IFB #2023-39

Northview Midrise Underground Water Storage Tank

ADDENDUM NO. #1

PWSA DETAILS 2 OF 2

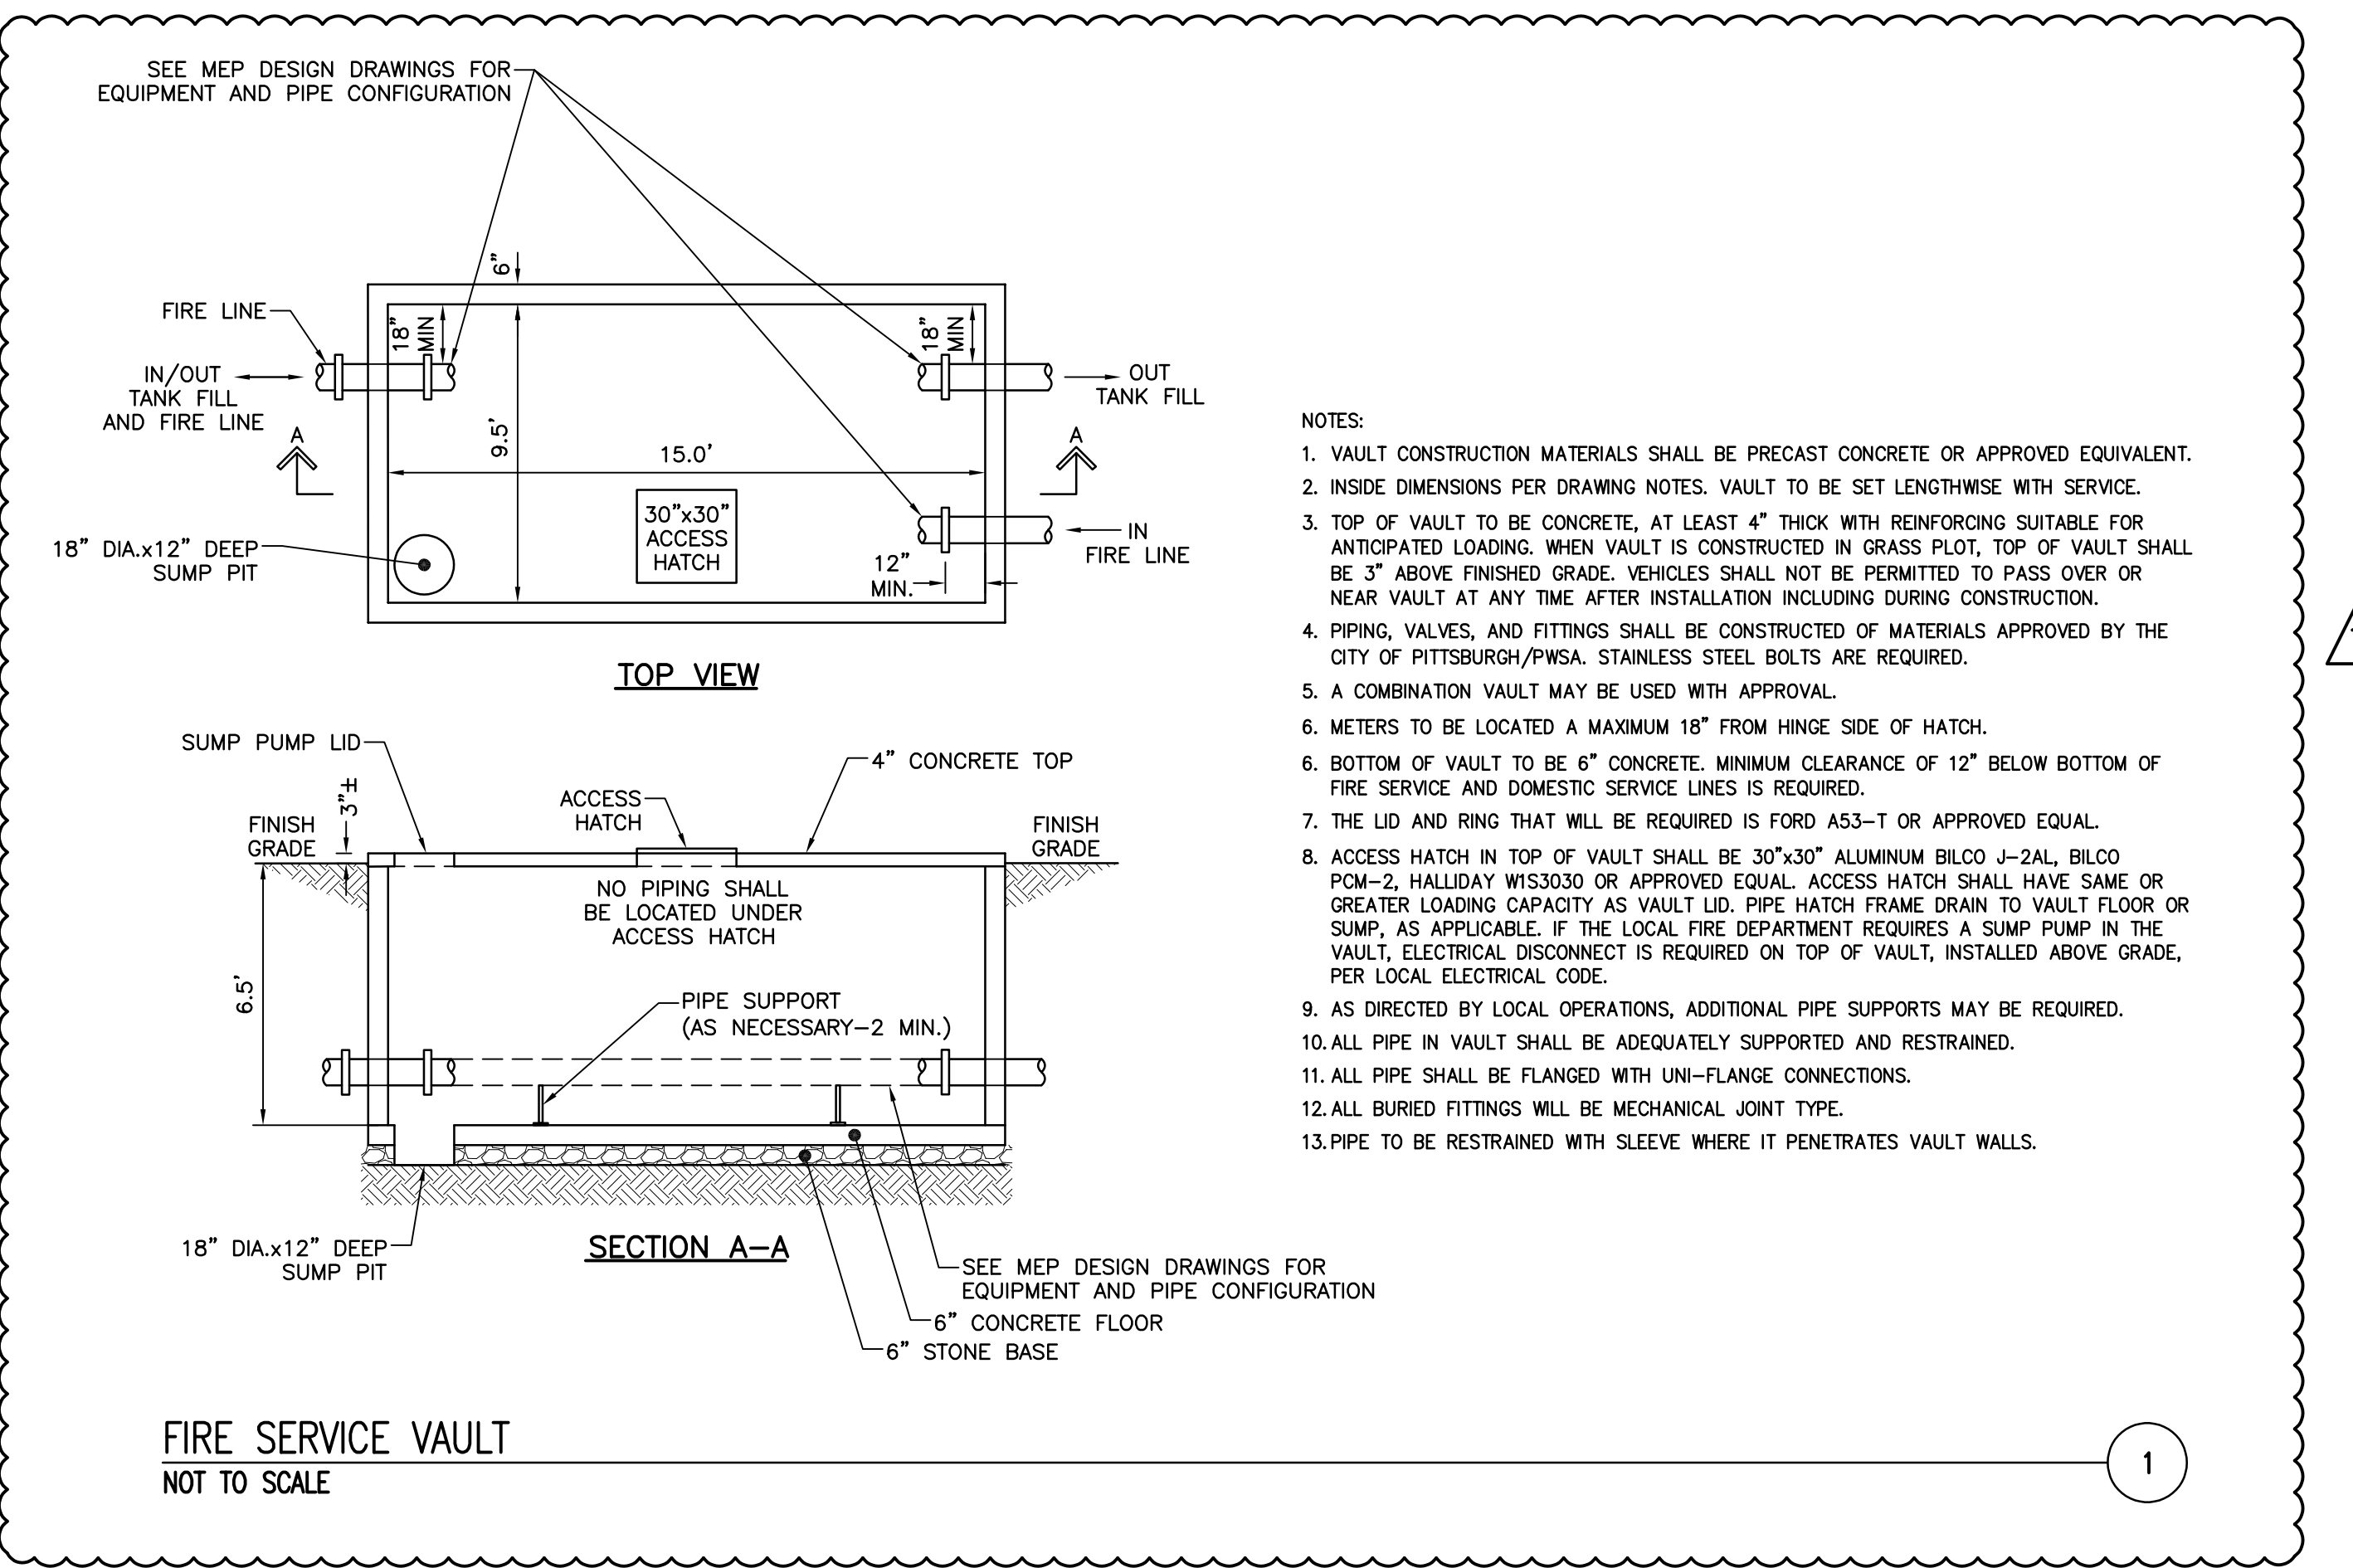
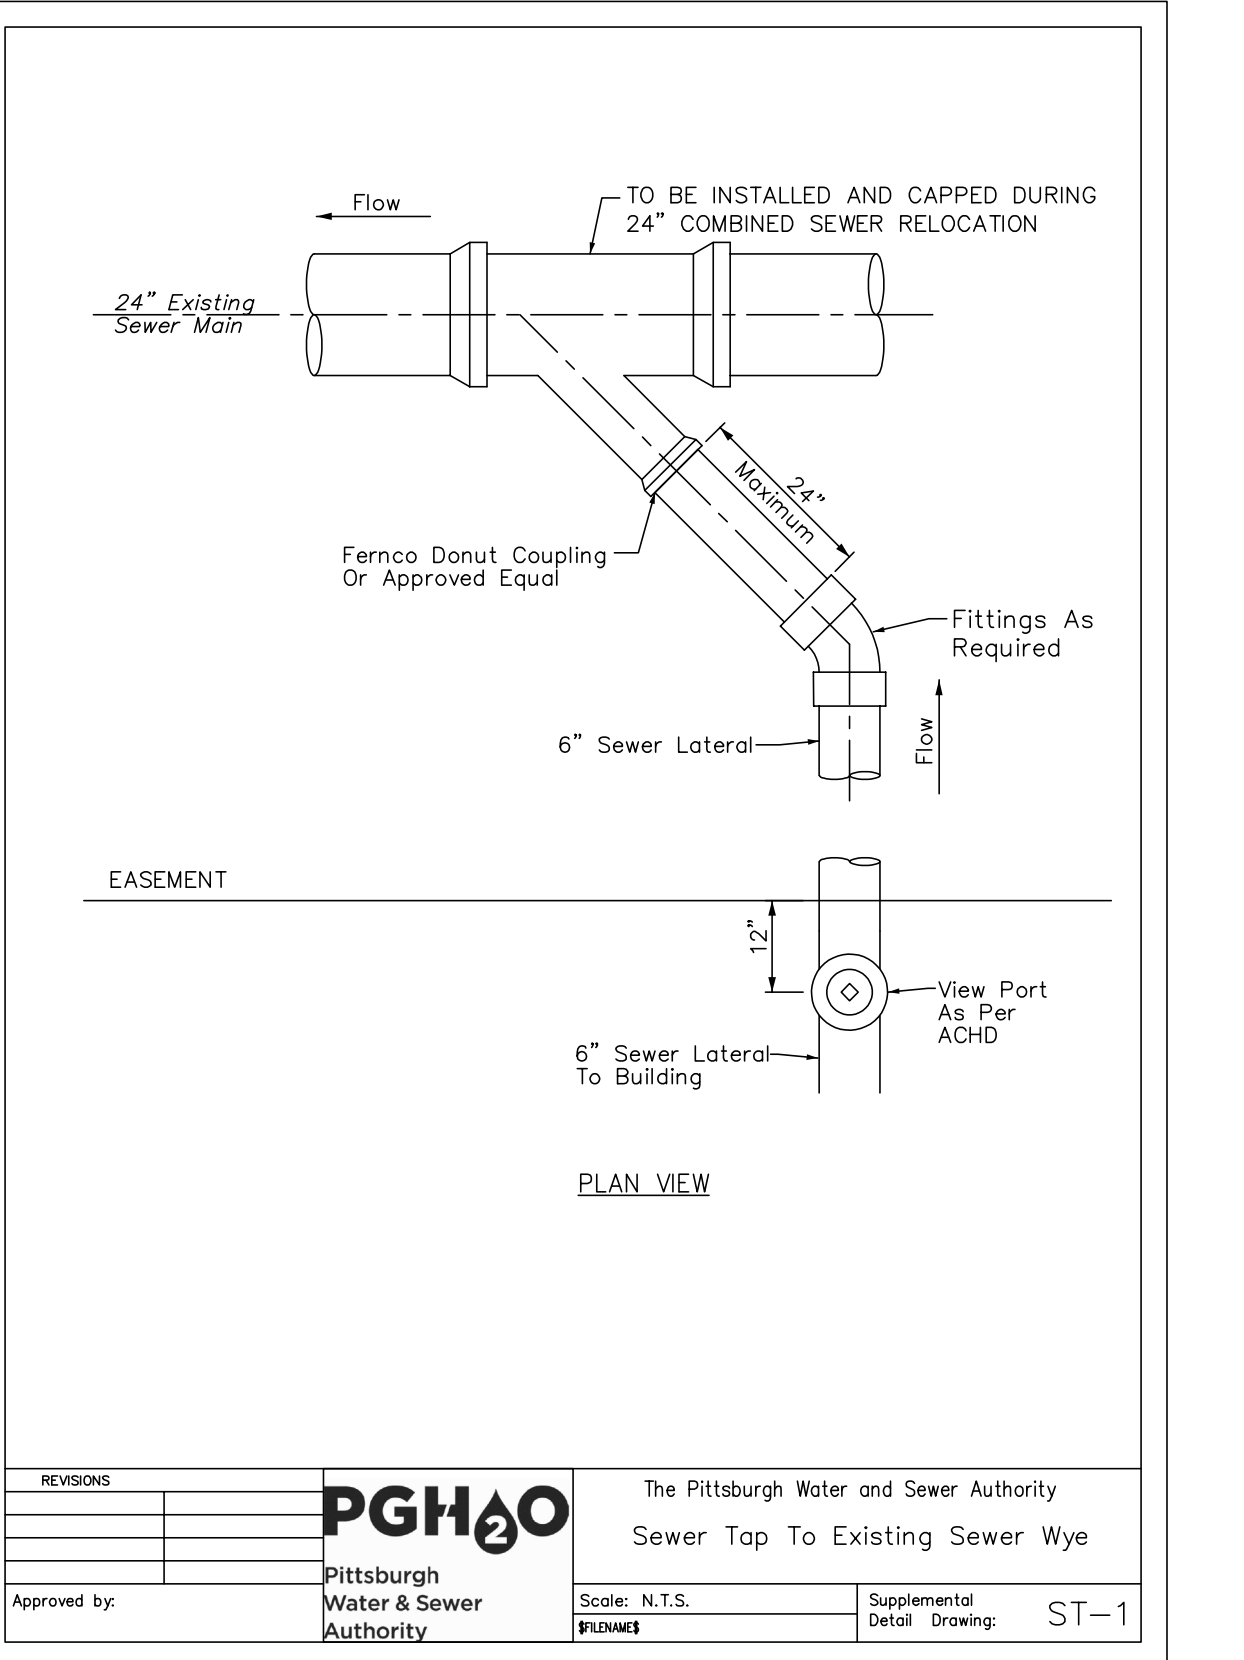
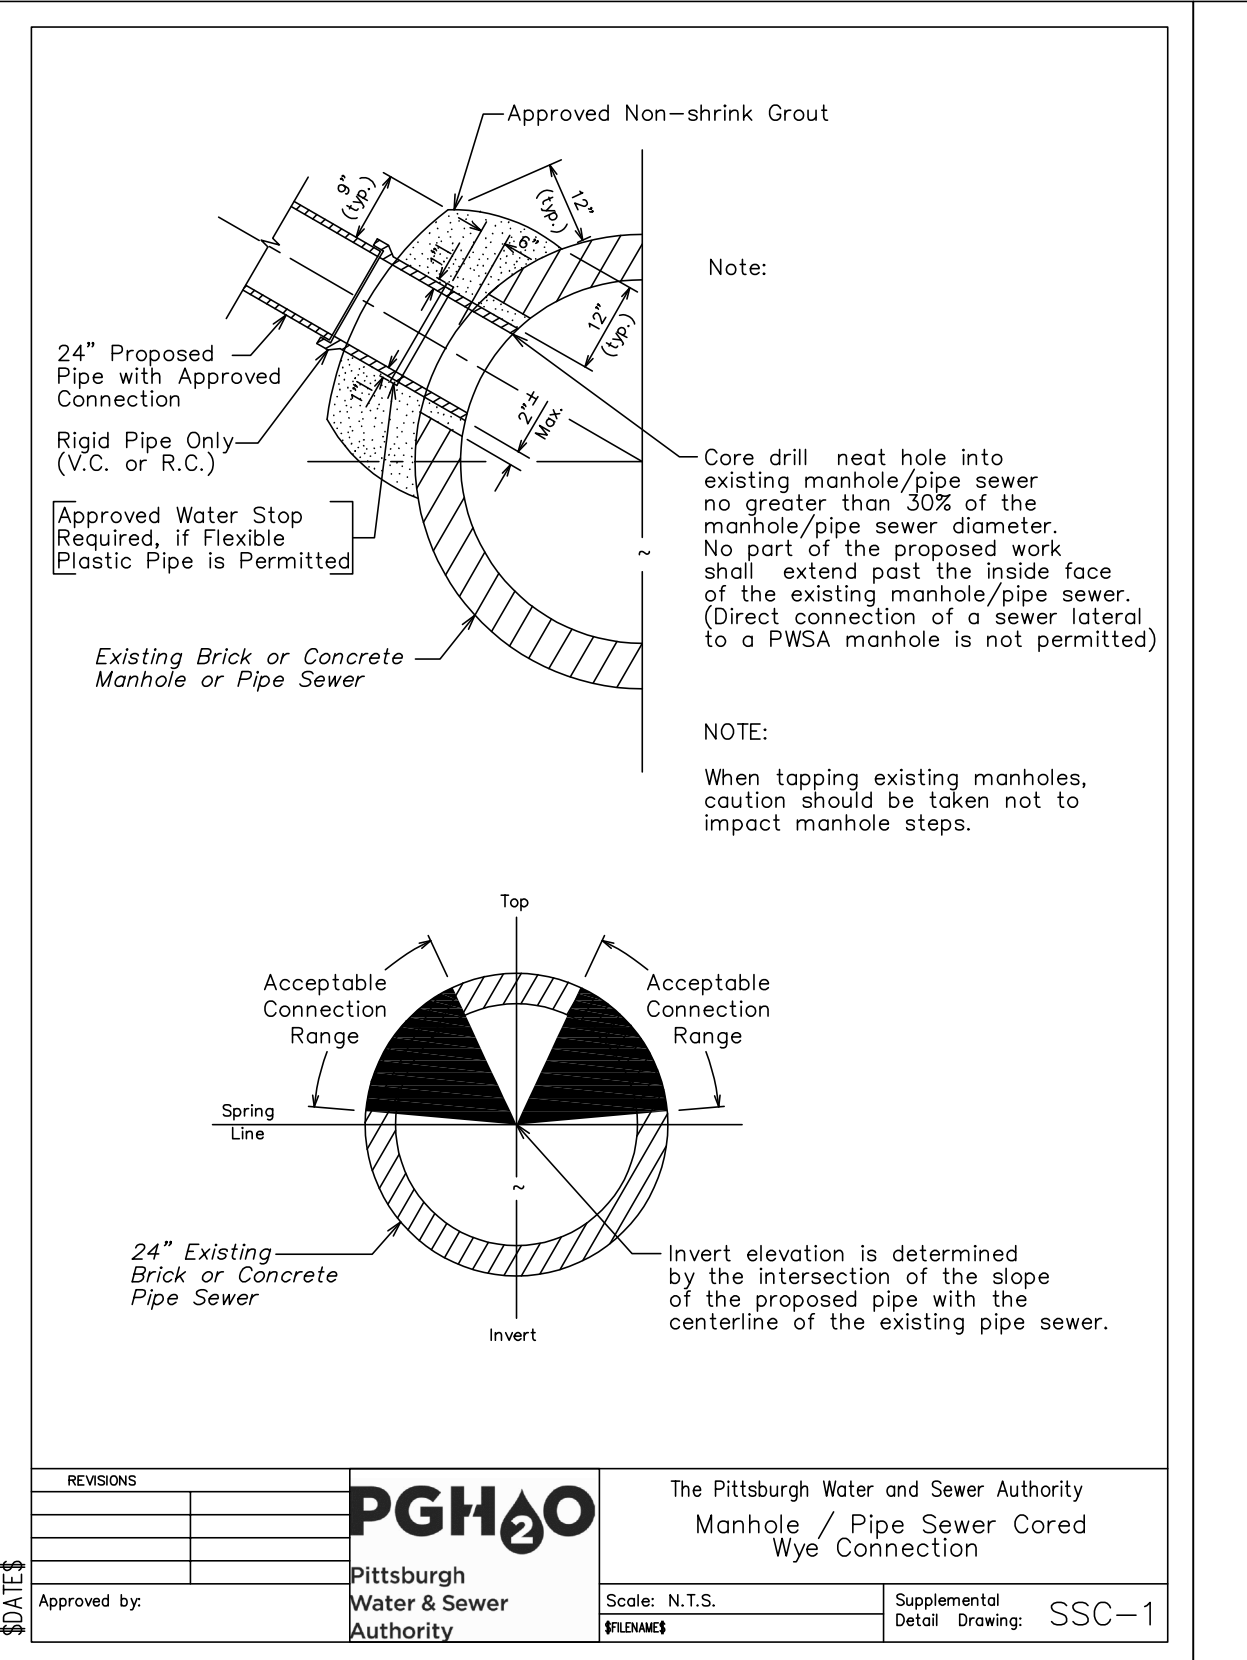
Item 3: The meter vault and water lines to the meter vault and storage tank have been relocated. Dimensional information for the meter vault has also been include along with minor revisions as noted as "Rev. 17". Attached are the revised sheets, C300, C400, C500, C552, C553, C554. C600. Please see Attachment A – Specifications Table of Contents and Section 33 16 00 and Attachment B – Civil Drawings for the aforementioned information.
